Enclosed for your information is one copy of Project Interface Document (PID) Number 06-S-47. This PID modifies the disposal cell configuration and location of gullies at the toe ditch. Modification to the disposal cell configuration was required due to the decrease in the amount of contaminated material placed in the cell. With this modification the cell design is now considered to be more conservative since the grade on the topslope was reduced while keeping the rock size the same. Since this PID does not affect the intent of the design it is considered to be a Class II modification. Therefore it does not require approval by the Colorado Department of Public Health and the Environment and the Nuclear Regulatory Commission.

UMTRA PROJECT
PROJECT INTERFACE DOCUMENT (PID)

Site: Rifle, Colorado	Date: February 22, 1996	PID No. 06-S-47	Site No. 06	Vic. Prop. No.
Originator and Location G. Cherrington, San Francisco	Phone: 415/442-7690	Organization: MKES	Answer By:	References: Subcontract: Subcontract No:
Subject: Revise Top Slope of Disposal Cell and Riprap Erosion Protection for Gullies at Toe Ditch

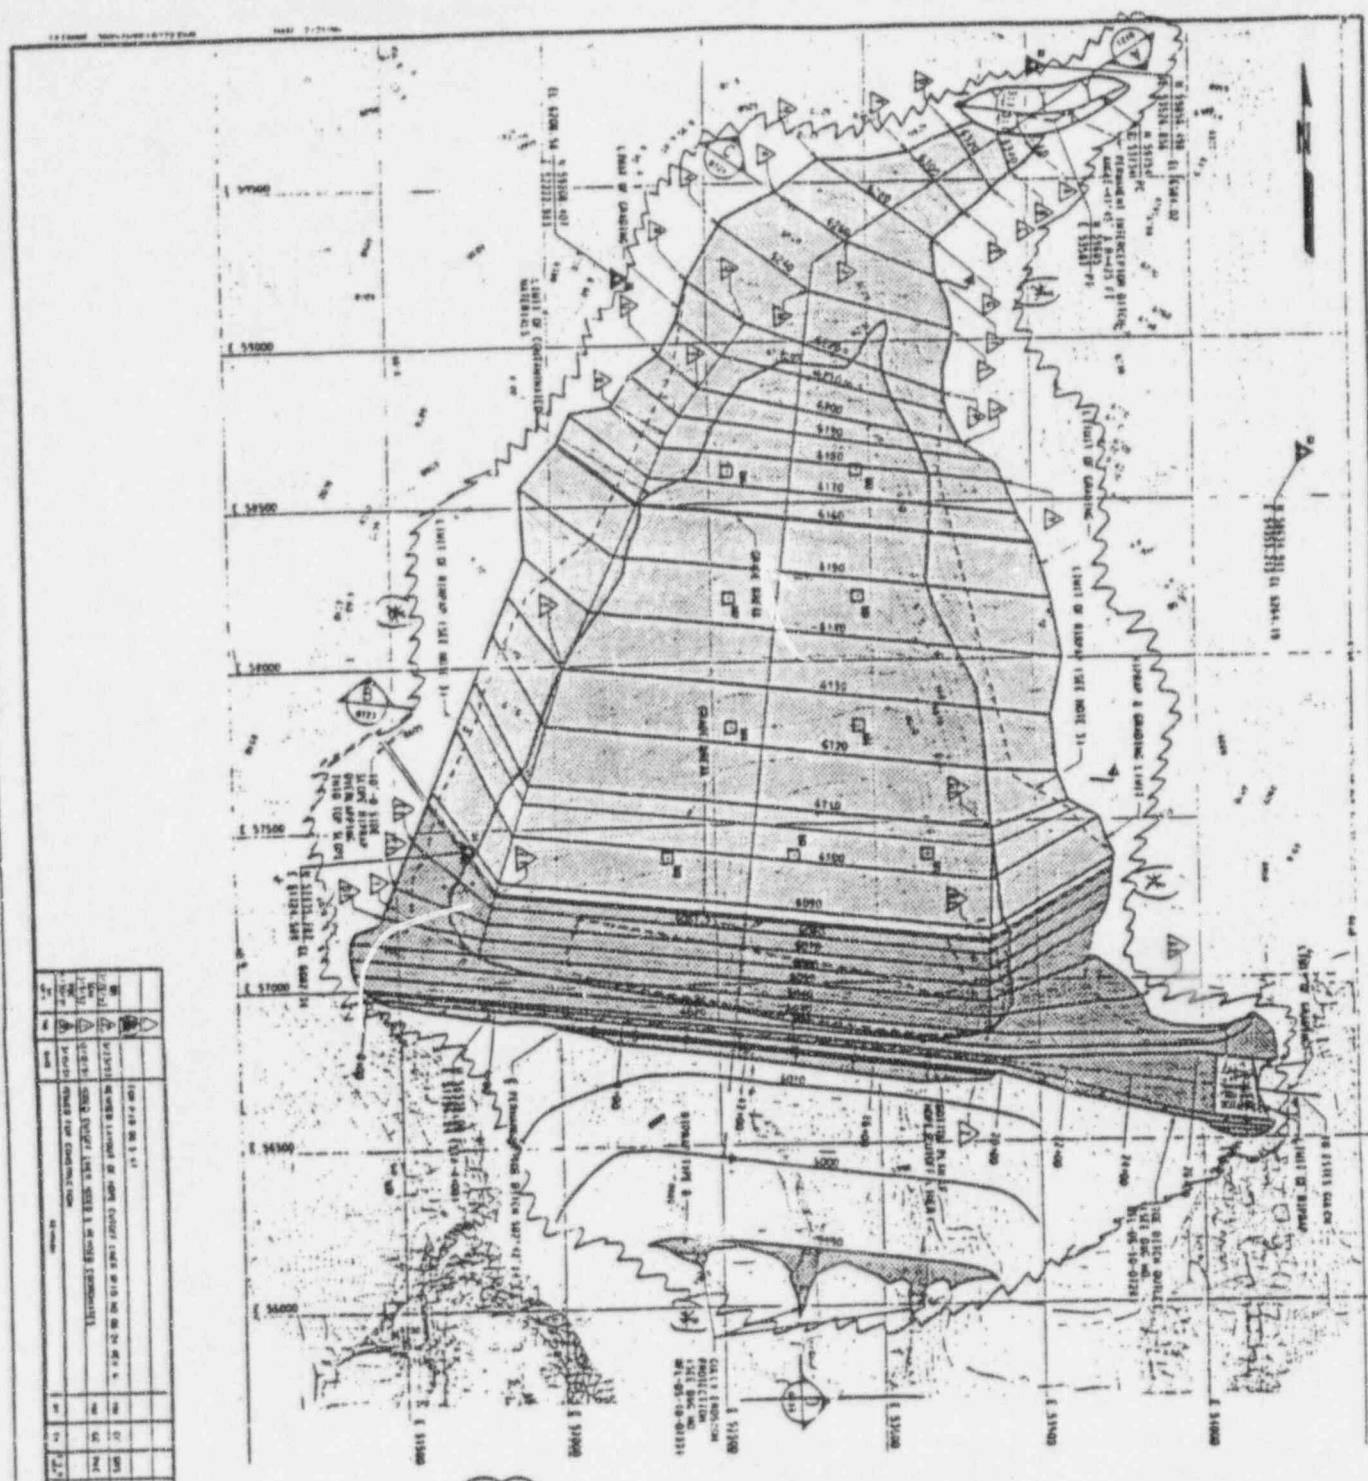
Since the three gullies abutting the permanent toe ditch have been filled in for a distance of about 600 ft to the south during construction of the temporary retention basin, it is proposed that gully erosion protection be provided at this new gully location rather than at the original location shown in Subcontract Drawing No. RFL-DS-10-0722 (Rev.2). The proposed method of gully erosion protection is as follows:

- (i) The surface of the filled-in gully area will be regraded to an approximate 4 percent slope to promote sheet flow. The regraded area will be seeded as required by Specification Section 02935.
- (ii) Provide a transition slope of 12.5 percent between the regraded surface and the existing ground surface, including the three gullies, which will facilitate sheet flow. This slope will also be extended into the three gullies. A 24-inch thick, Type B riprap layer will be placed over this slope for erosion protection.
- (iii) Type C riprap will be placed to a minimum thickness of 30 inches at the downstream end of Type B riprap in the three gullies.

FINAL SITE GRADING AND DRAINAGE PLAN

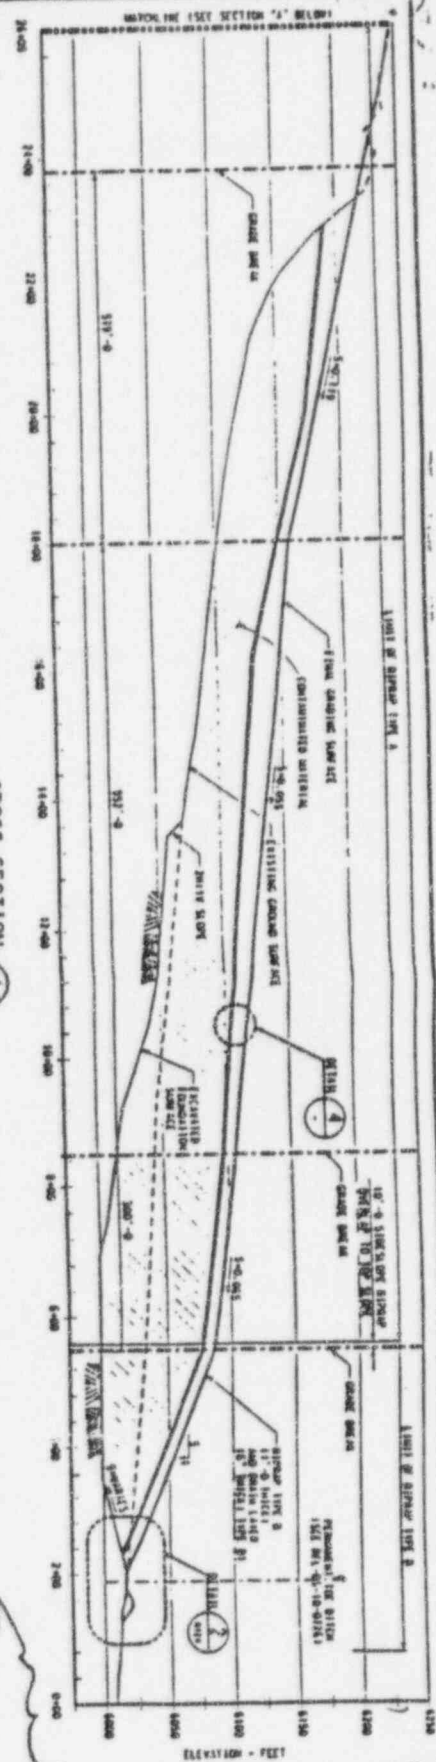
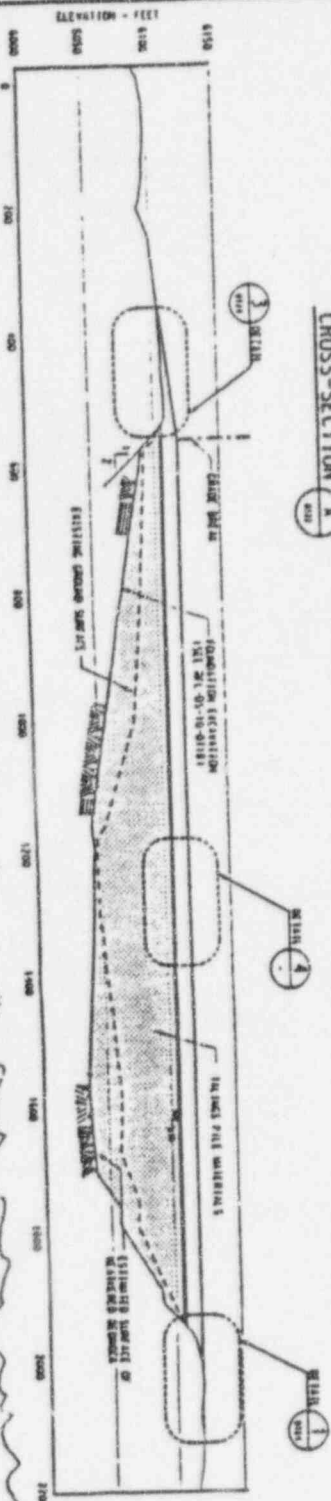
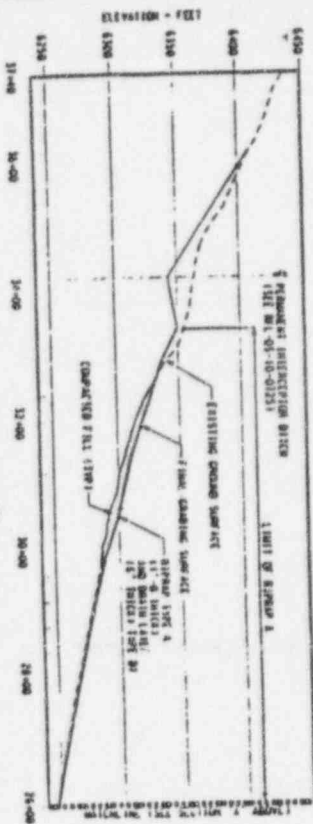
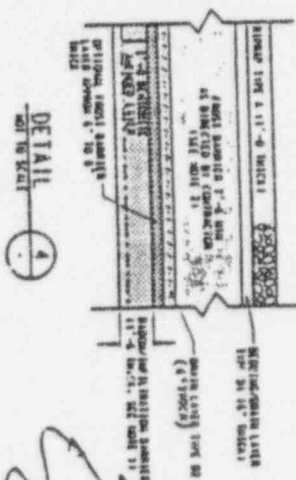
The following Subcontract Drawings will be revised in accordance with the attached markups to implement the design changes as proposed above for Solutions No. 1 and No. 2.
